PREVOST

IS-20057

New DPF DELTA P Sensor

PART# 23488881 replacement for 21403962 obsolete.

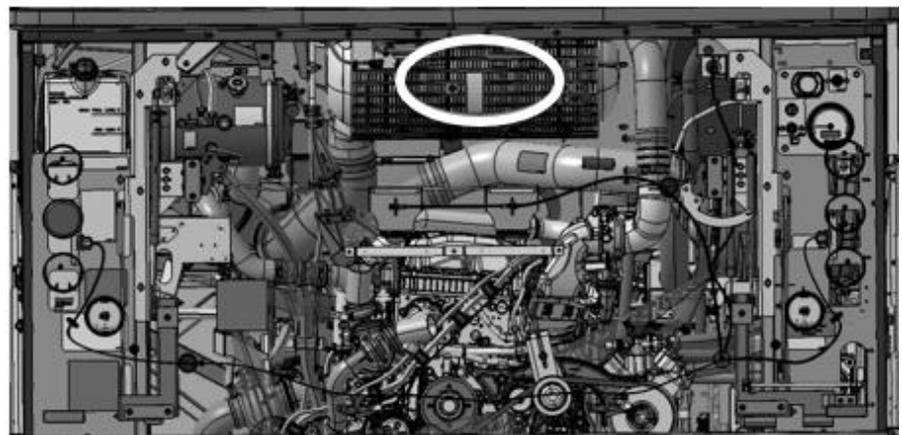
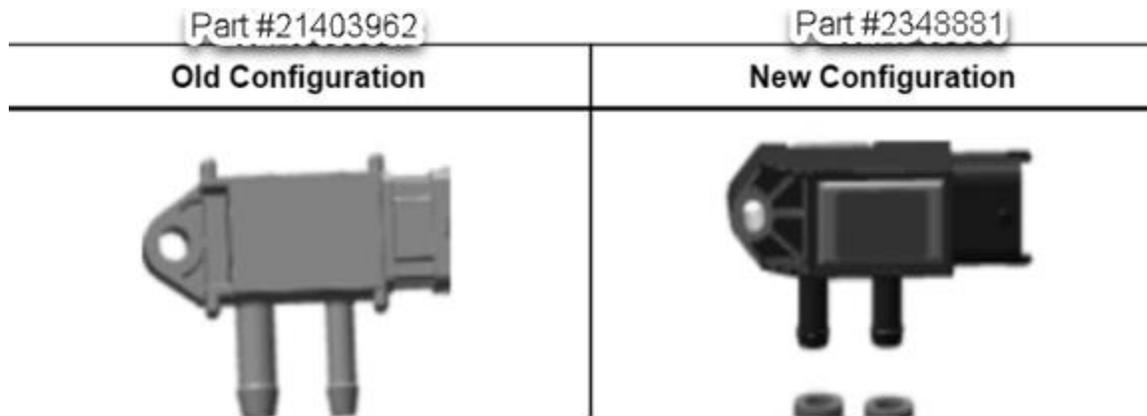
2. The old DPF sensor as a low-pressure port with a 6 mm diameter and a high-pressure port with an 8 mm diameter. The new DPF sensor has both high and low ports with an 8 mm diameter.

New configuration

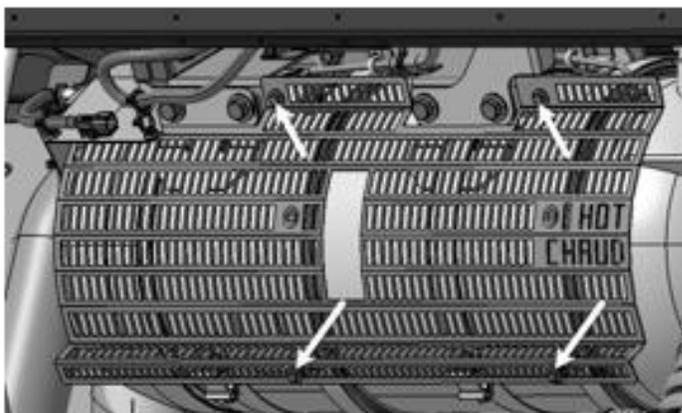
3. Part 21403962 is replaced by 23488881

4. Replace by the new configuration assembly 040096.

10. **XL series 2020 and newer:**

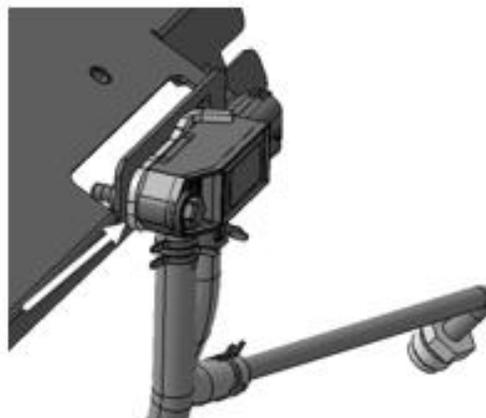
Installation of the spacer 040097 between the structure and the new sensor 23488881.
